FINAL
STORM WATER DISCHARGE
MANAGEMENT PLAN

IR-01/21, Industrial Landfill, Parcel E
Hunters Point Shipyard, San Francisco, California

June 12, 2003

Enclosure (1) is provided for your review and records. Thank you for your comments and contributions to this final document. Also, attached to the final document are the final response to comments.

FIGURE 5
DRAINAGE SYSTEM FOR
NORTHEASTERN AREA OF IR-01/21
Final Storm Water Discharge Management Plan
IR-01/21 Industrial Landfill, Parcel E

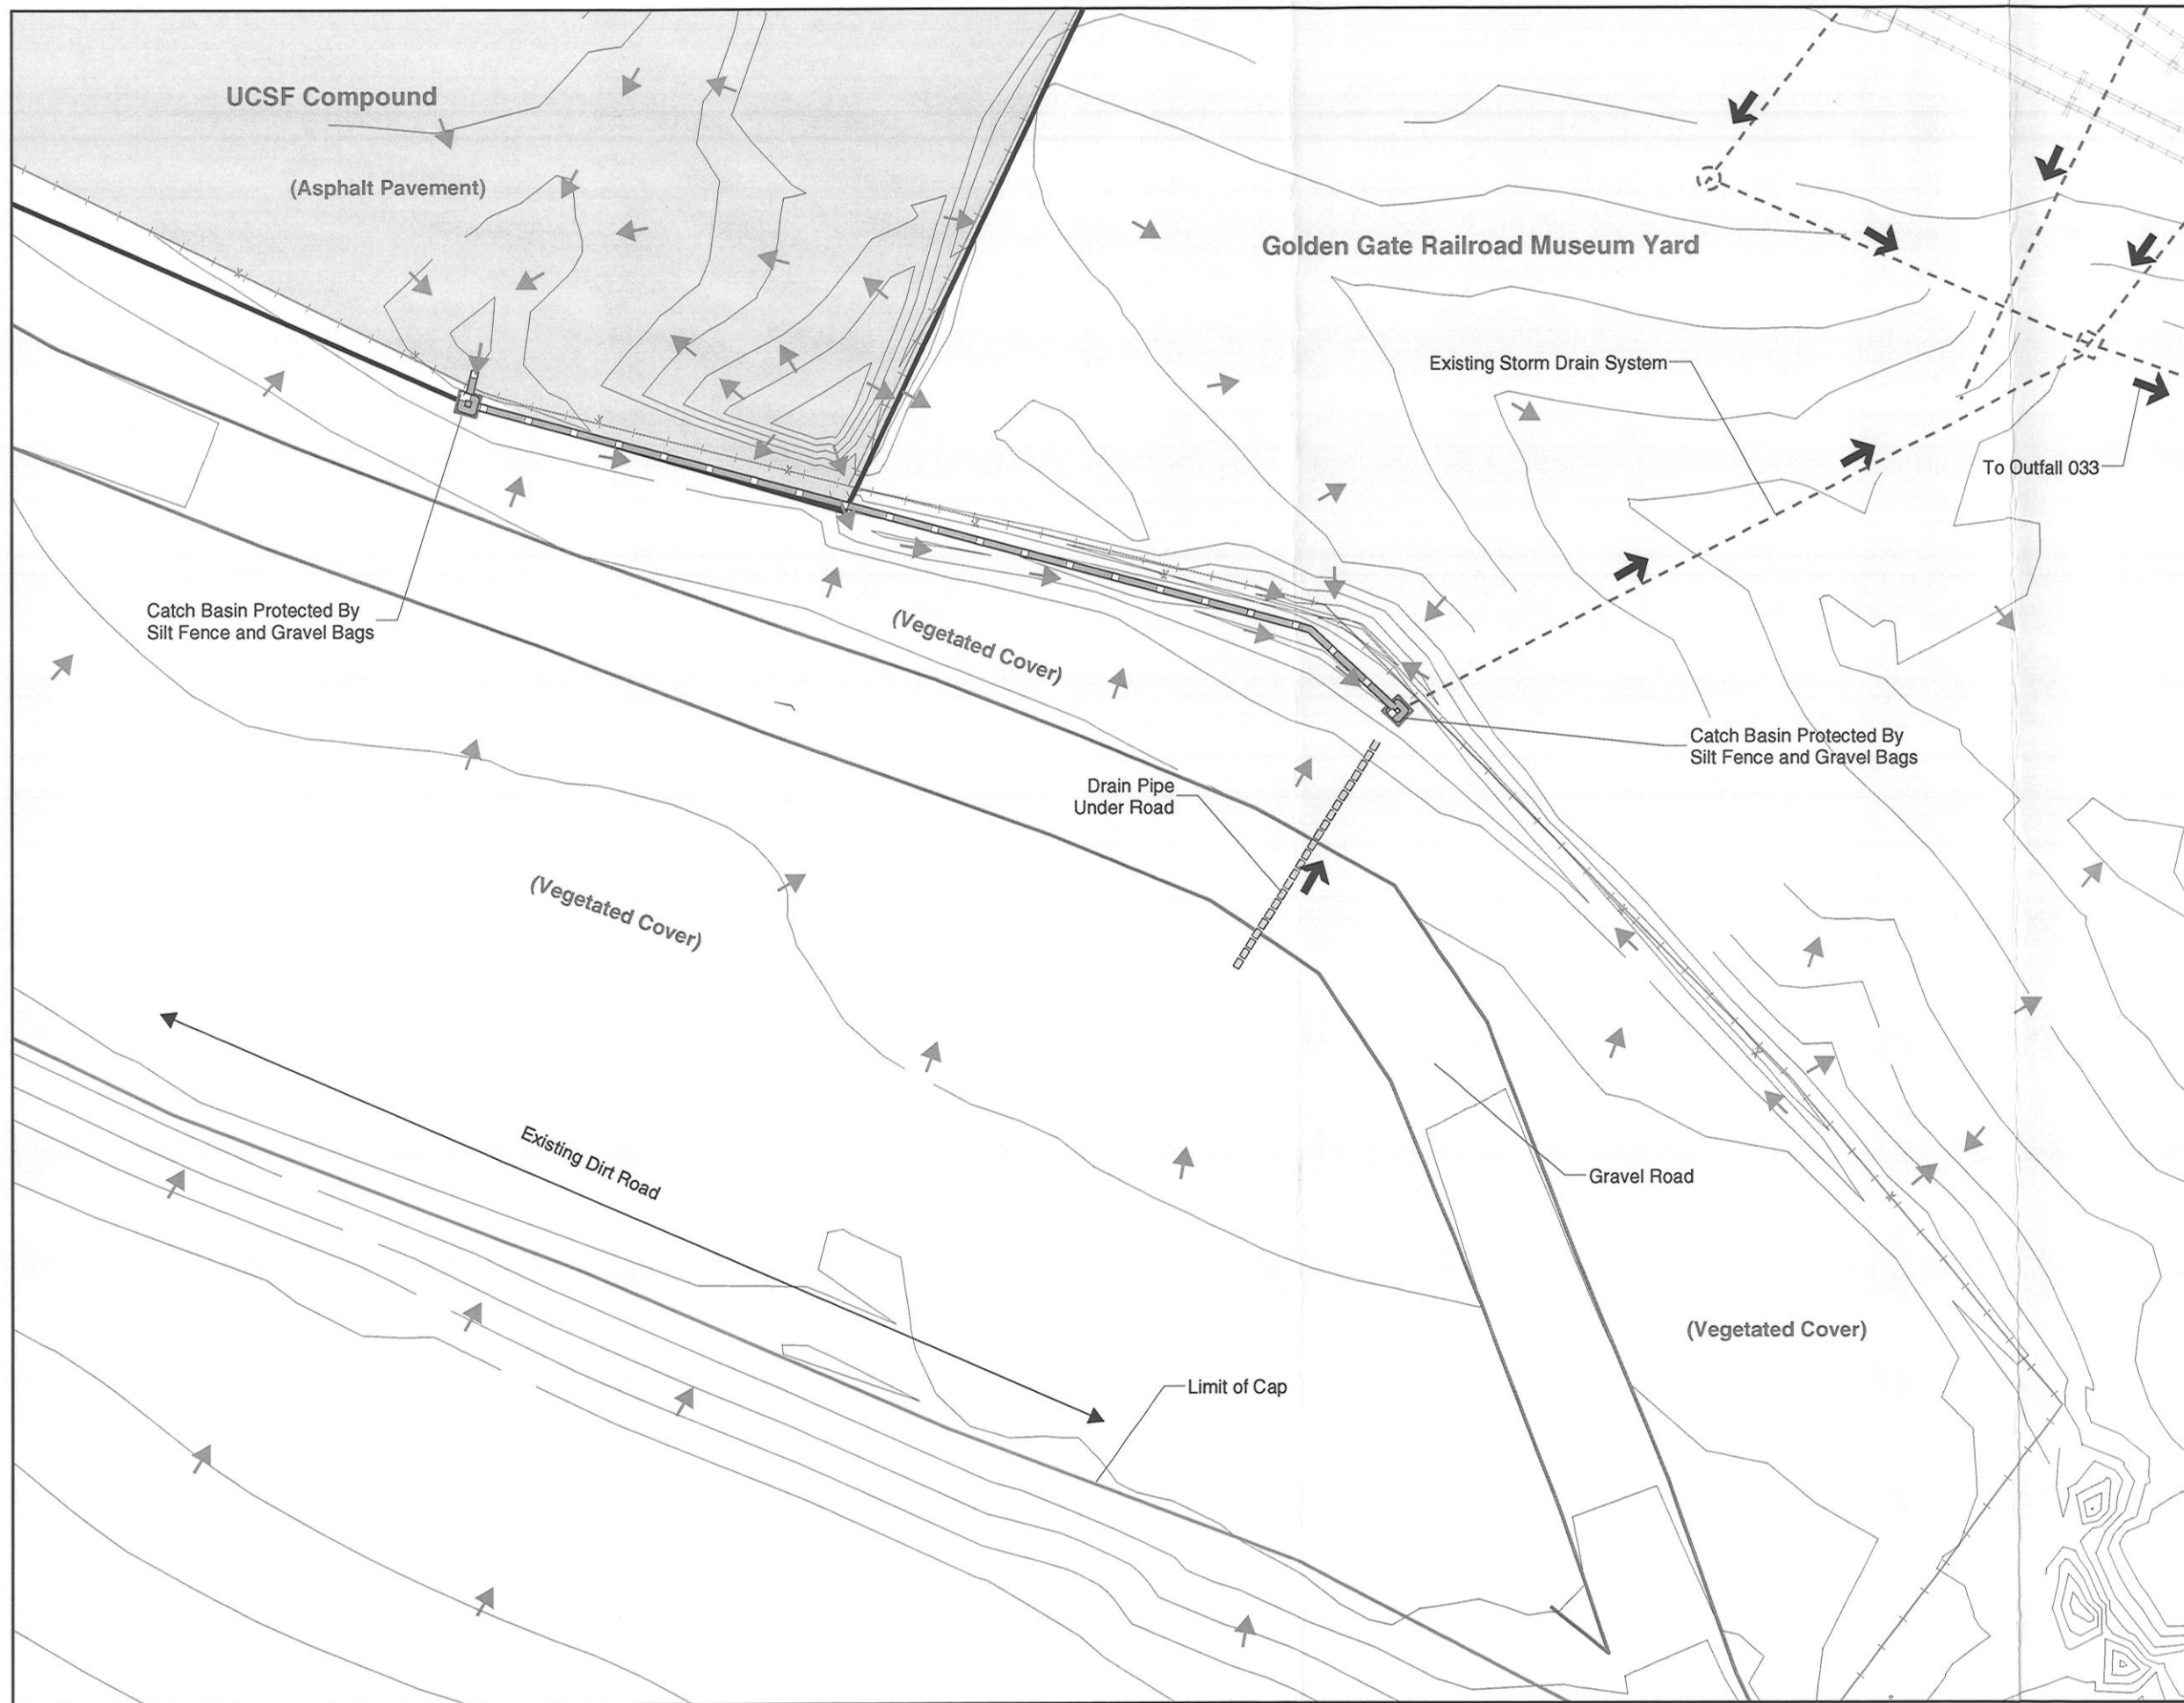
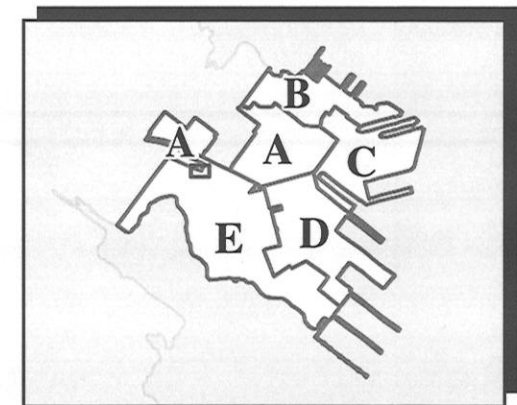
9. **Comment:** **Figure 5, Site Features and BMPs:** Please revise this figure as follows:

Response: The Navy has revised Figure 5 of the final SWDMP to show the locations of discharge, sampling, and visual observation, and the proposed location of the sedimentation basin. Appendix E of the final O&M plan includes locations and details of the cap drainage layer and underdrain pipe (Tetra Tech 2003).

Photo 1. Jute mat within a portion of the drainage ditch along the north side of the facility surrounded by large area of unprotected dirt.

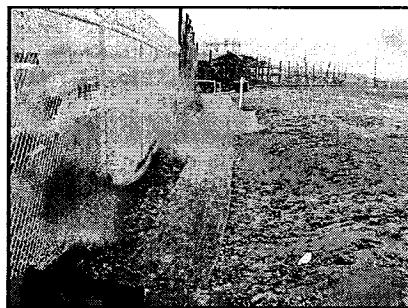
- 1. Comment:** During Board staff's February 12, 2003 inspection of the landfill, it was observed that although a vegetative cap covers much of the landfill, there are large areas, including roads, portions of the landfill cap, and drainage ditches that are within areas that are completely unprotected (see Photos 1 and 2). The existing Best Management Practice (BMP) implementation was not in compliance with the State Water Resources Control Board General Permit for Storm Water Discharges Associated with Industrial Activities (NPDES Permit No. CAS000001 – Industrial General Permit), which requires identification and implementation of BMPs that will effectively prevent discharges of pollutants to waters of the State.

Appropriate BMPs should be implemented immediately in these areas to prevent further erosion, which could result in a discharge of sediment or other contaminants into drainage ditches, catch basins, and the San Francisco Bay. The post-construction BMPs described in the General Permit for Storm Water Discharges Associated with Construction Activity (SWRCB Order No. 99-08-DWQ – Construction General Permit) are considered by Board staff to be appropriate BMPs to utilize under the Industrial General Permit, because the subject facility is primarily unpaved and includes areas that have been recently disturbed by construction activities.

Photo 3. Catch basin and silt fence surrounded by unprotected soil, allowing sediment laden storm water to pass through the silt fence into the catch basin and storm drain.

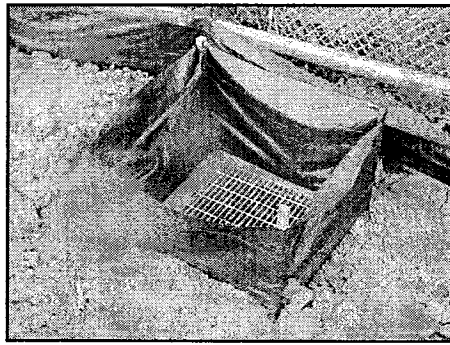
8. Comment: Section 4.3.8, Erosion and Sediment Controls, Page 34:

The text states that an underground drainage pipe and catch basin would be installed with a 4-by-4-foot square silt fence around the catch basin grate as a temporary sediment control measure while vegetation in the area is being established. Photo 3 shows that this catch basin and silt fence are surrounded by unprotected soil. As stated above, some type of soil cover must be implemented while waiting for the vegetation to be established. Secondly, Board staff believes that a silt fence is not an adequate sediment control measure for the area around the catch basin as sediment-laden stormwater migration could occur through the silt fence. A BMP that will effectively filter sediment, such as sand or gravel bags or fiber rolls should be placed around the catch basins. In addition, Section 4.2.2 and Figure 4 should be revised to include a description of the route and ultimate destination of the storm drain flow in this area.

Response: The Navy has installed vegetation, silt fences, and gravel bags in these areas. RWQCB noted that these controls had been installed during a subsequent site tour conducted on March 6, 2003.
